# Town of Paradise Valley

## Meeting Notice and Agenda Planning Commission

**A.     [25-161](#)           Discussion and Possible Action on Smoke Tree Resort  
Minor Special Use Permit (SUP-25-03)  
7101 E Lincoln Drive**

The applicant requests a Minor Special Use Permit (SUP) amendment (SUP-25-03) for the Smoke Tree Resort to the Major Special Use Permit approved in January 2024 (SUP-23-01). The request will maintain a similar footprint and building layout to SUP-23-01. This amendment is for an increase of the guestroom count from 82 keys to 95 keys (while reducing the gross building area) along with other minor modifications (e.g., increasing the number of parking spaces, adjoining the fitness area to the spa, and similar modifications). The resort is located at 7101 E Lincoln Drive (Maricopa County Assessor Number 174-64-003A). The request is submitted by Withey Morris, PLC, on behalf of ST HOLDCO, LLC, a Delaware limited partnership (being the land asset management and global real estate company called Walton Global Holdings).

**Figure 11: Proposed Lane Configurations and Traffic Controls**

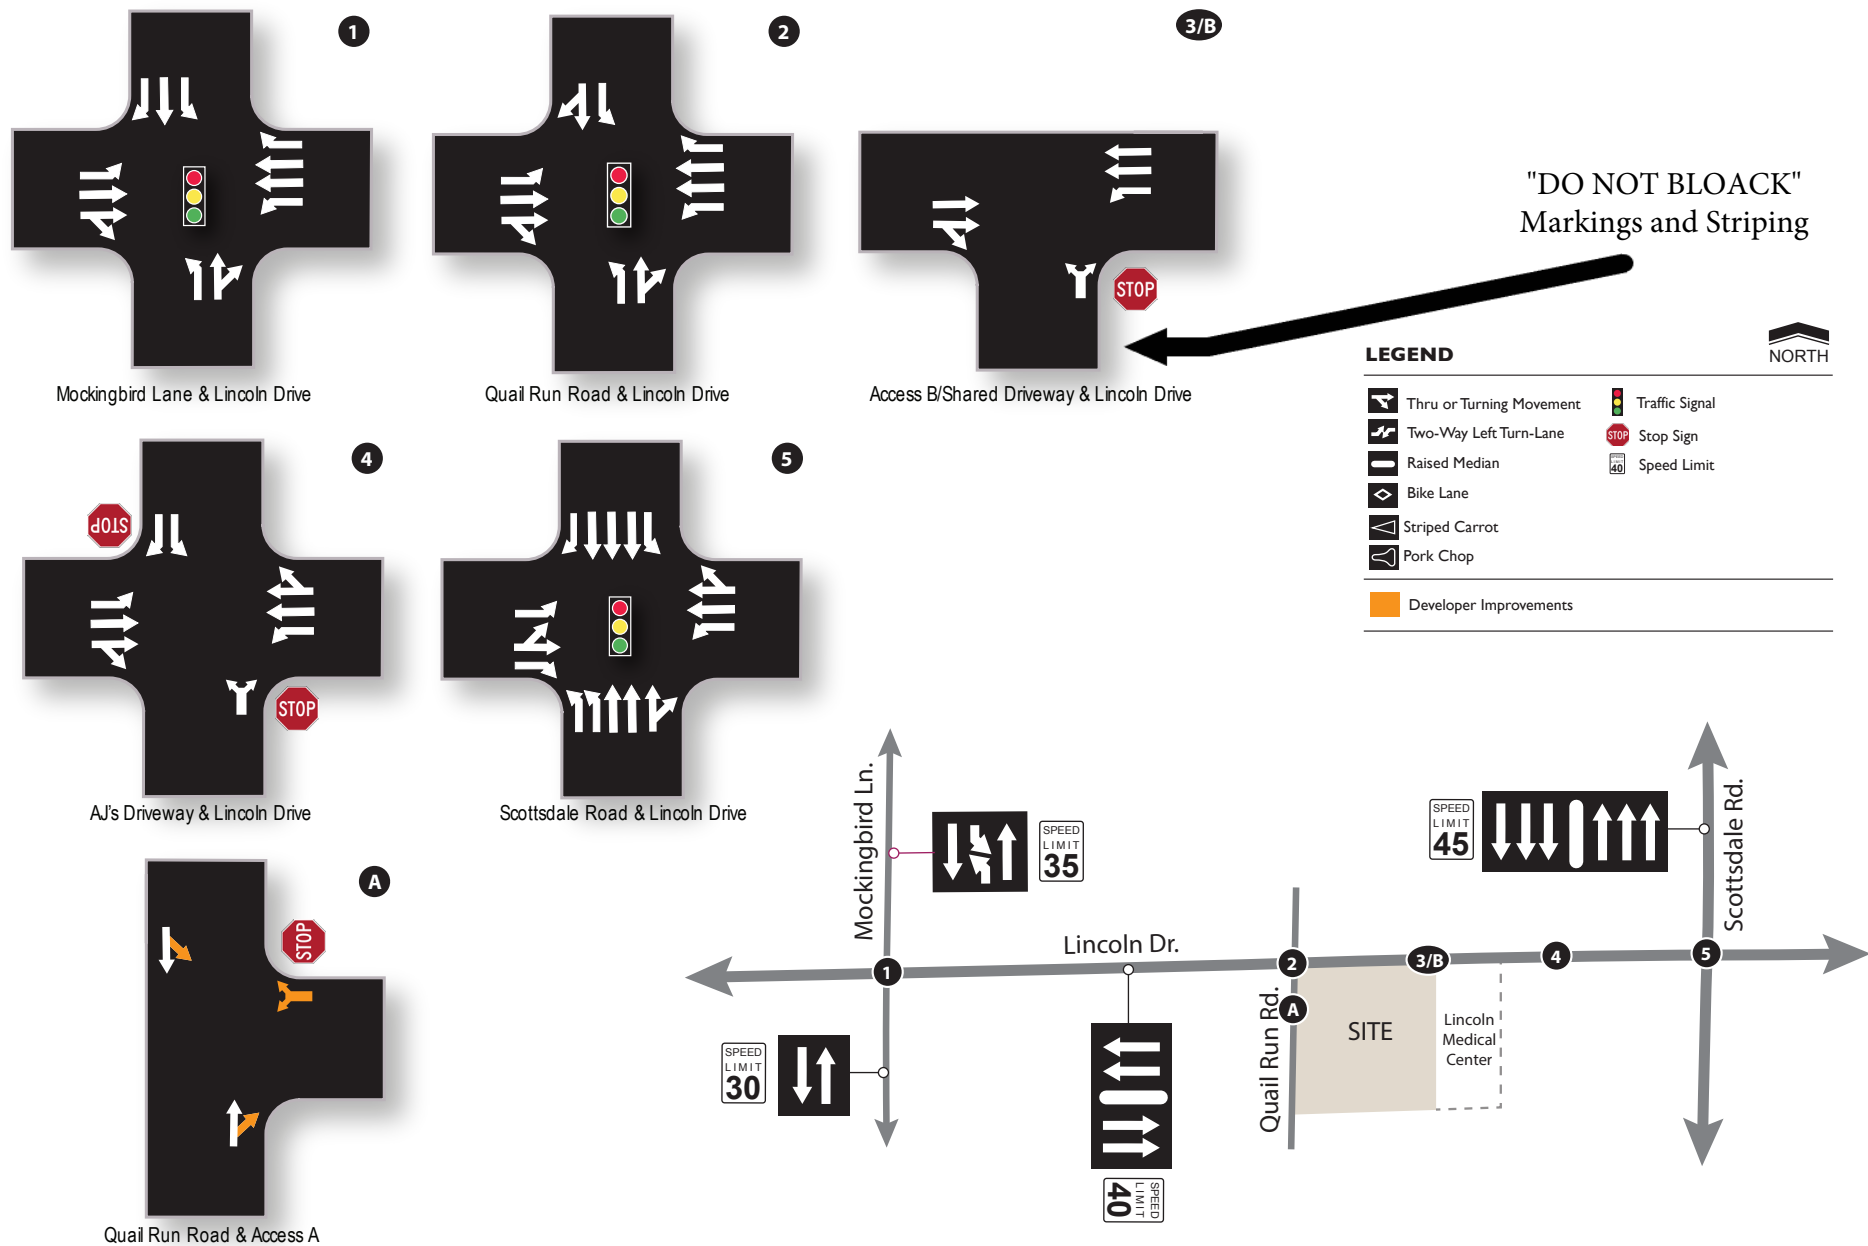
24.	<b>Figure 11</b> - Revise to match existing lane geometry comments. Also, the TIA notes that the southbound approach at Quail Run Rd/Lincoln Dr will include a southbound right turn lane. This should be reflected in this figure as a future improvement by others.	Existing lane geometry updates have been carried through. The SBR turn lane discussion has been removed and not included within the figure.
